***PRELIMINARY DRAINAGE REPORT***

**Reserve at Black Mountain  
Scottsdale, Arizona**

**Case No. 536-PA-2016**

Re: Drainage review comments for Reserve at Black Mountain.  
Case number: 26-ZN-2016  
Review date: 11-30-2016

HEC-RAS Plan: ExistingCond River: Wash 140 Reach: Reach 1 Profile: 100yr

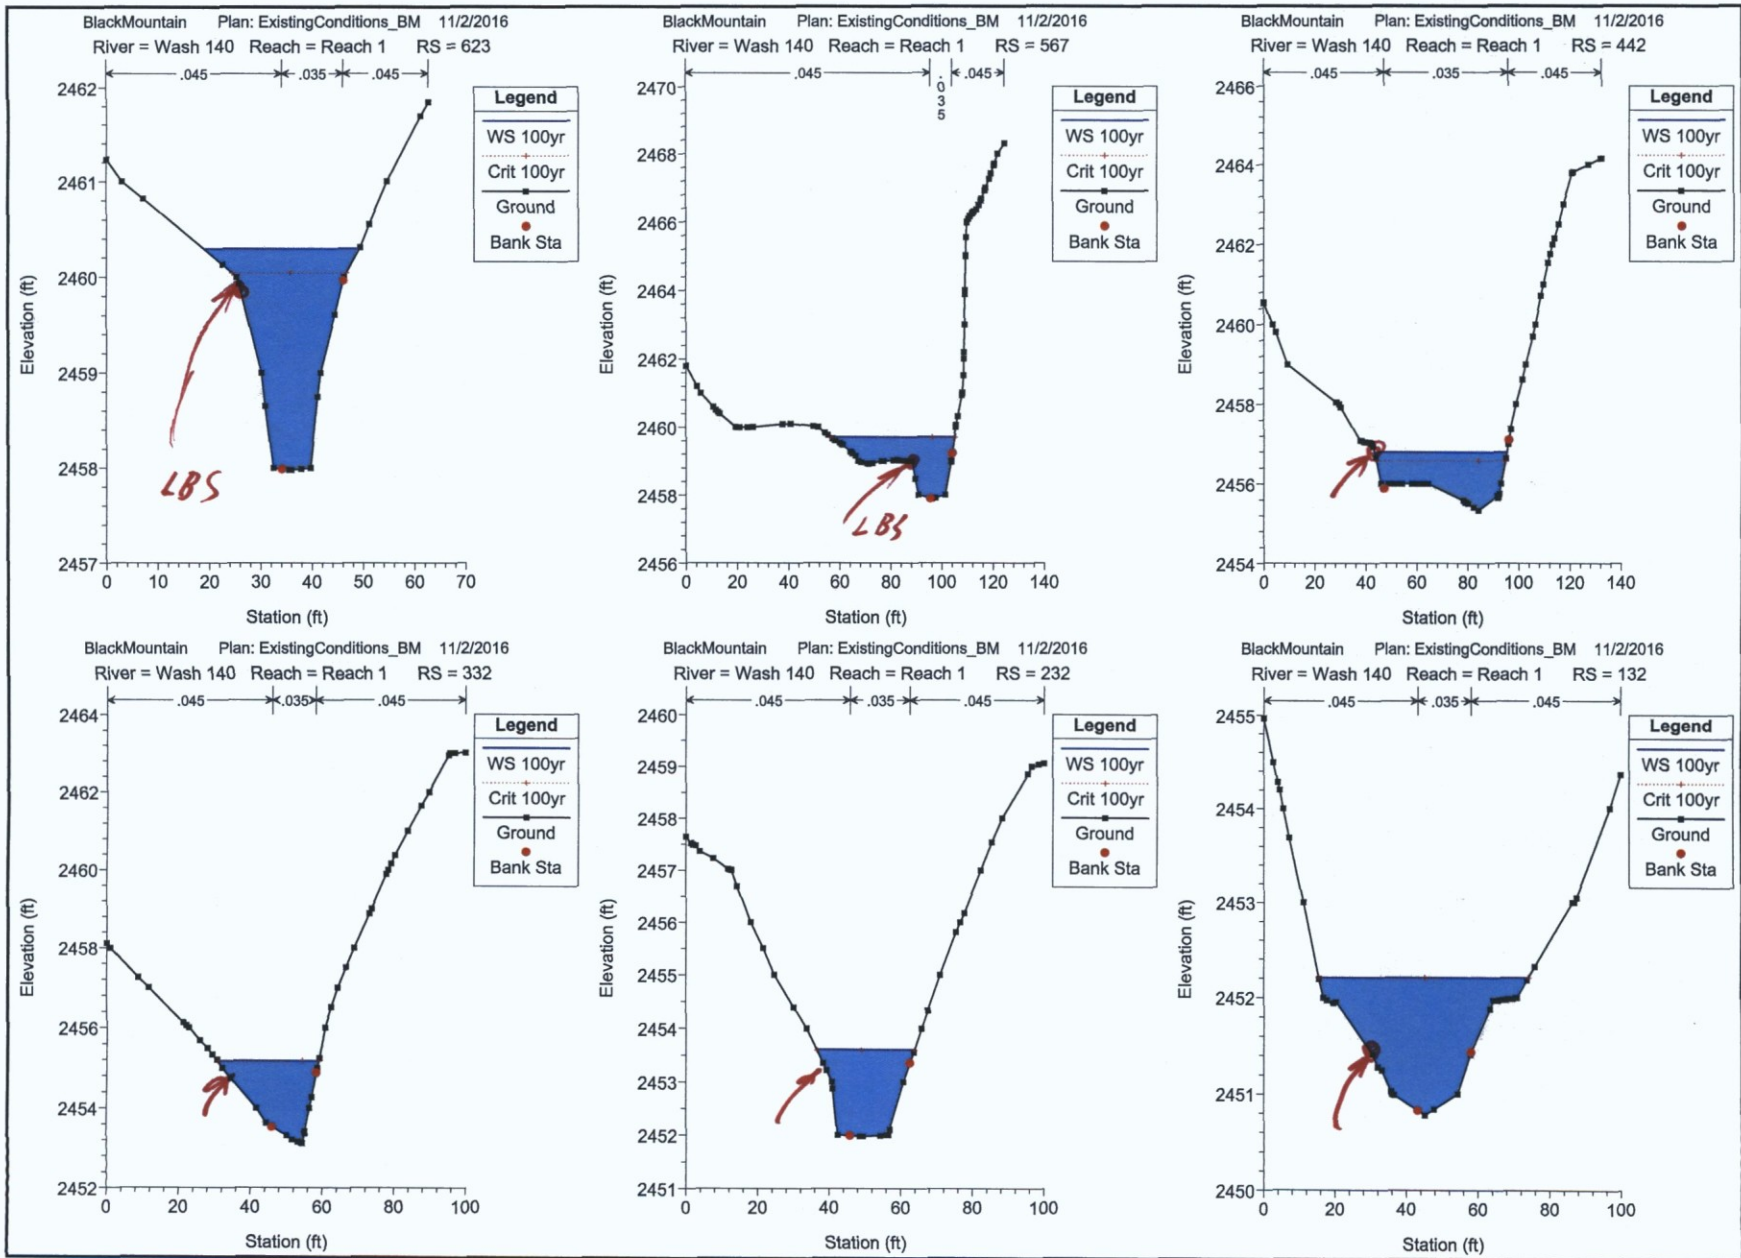
SUBMIT DIGITAL HEC-RAS  
MODEL. REVISE BANK STATIONS. (TYP)

RESERVE AT BLACK MOUNTAIN  
 FIGURE 8  
 PROPOSED CONDITIONS  
 DRAINAGE MAP  
 DATE: 12/21/2016  
 SCOTTSDALE, ARIZONA

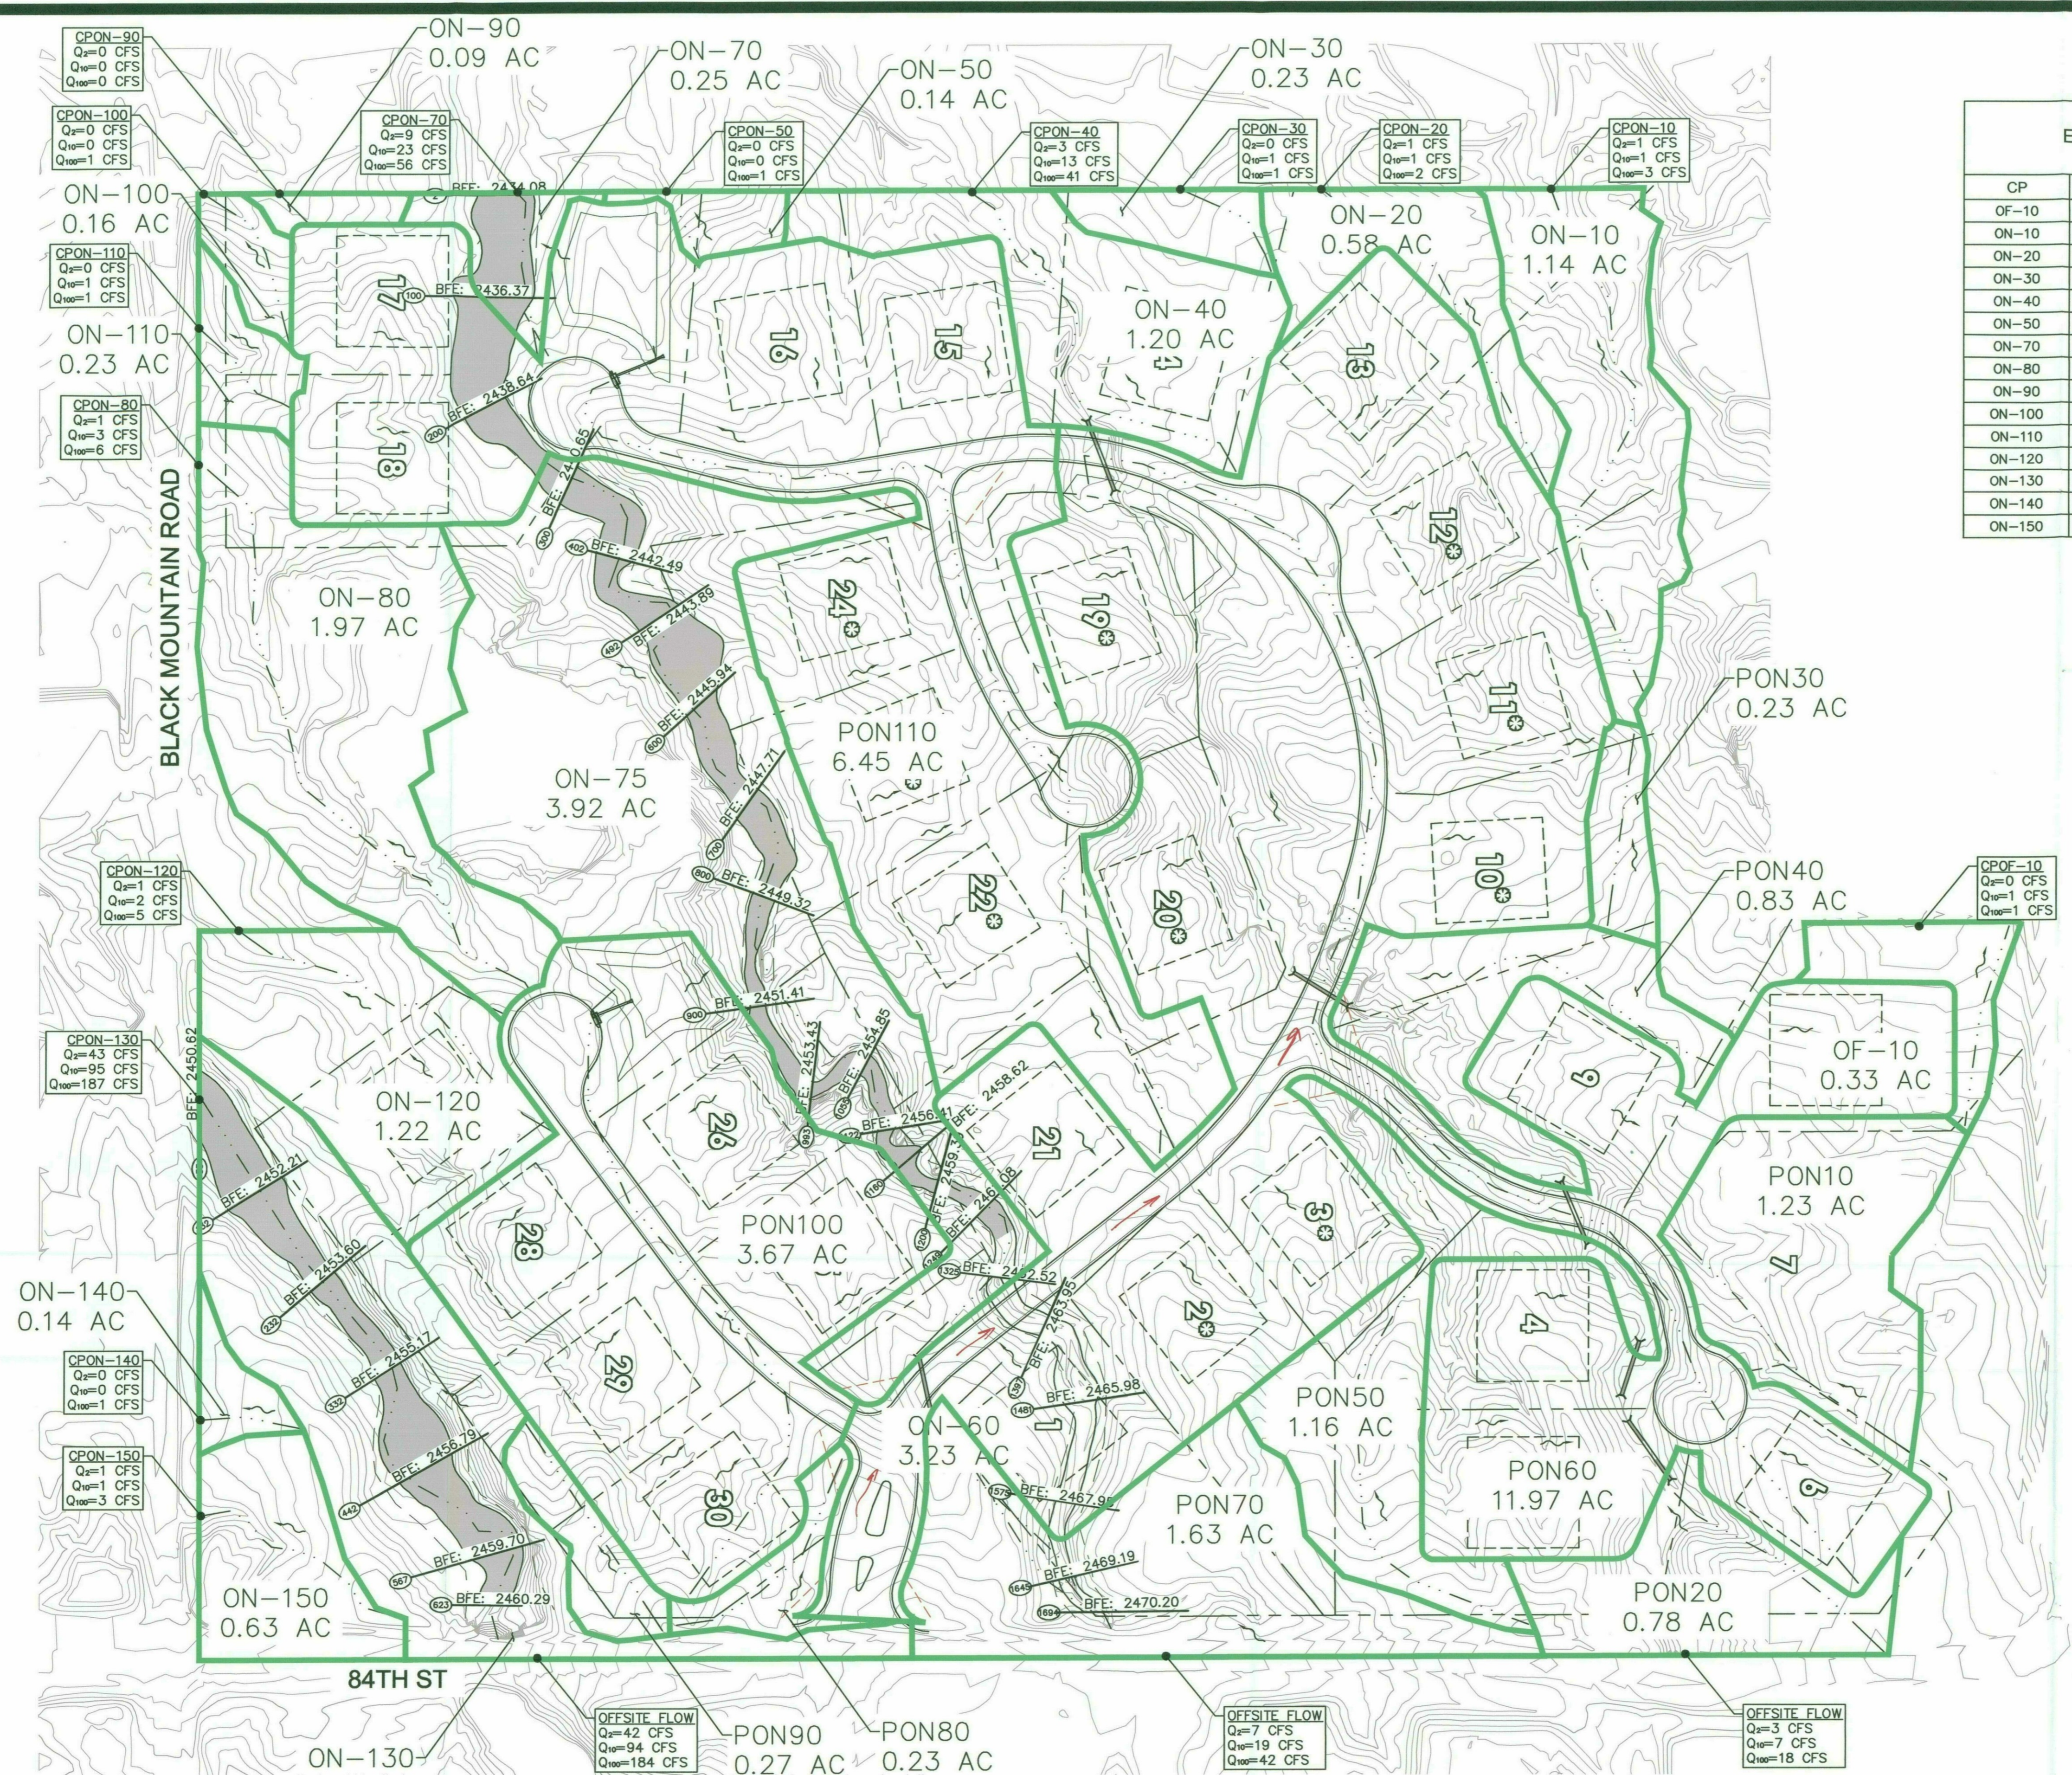
ADD COLUMN FOR PROPOSED CONDITION NODE NAME WHEN DIFFERENT THAN EX CONDITION.

ADD PROPOSED CONTOUR LAYER.
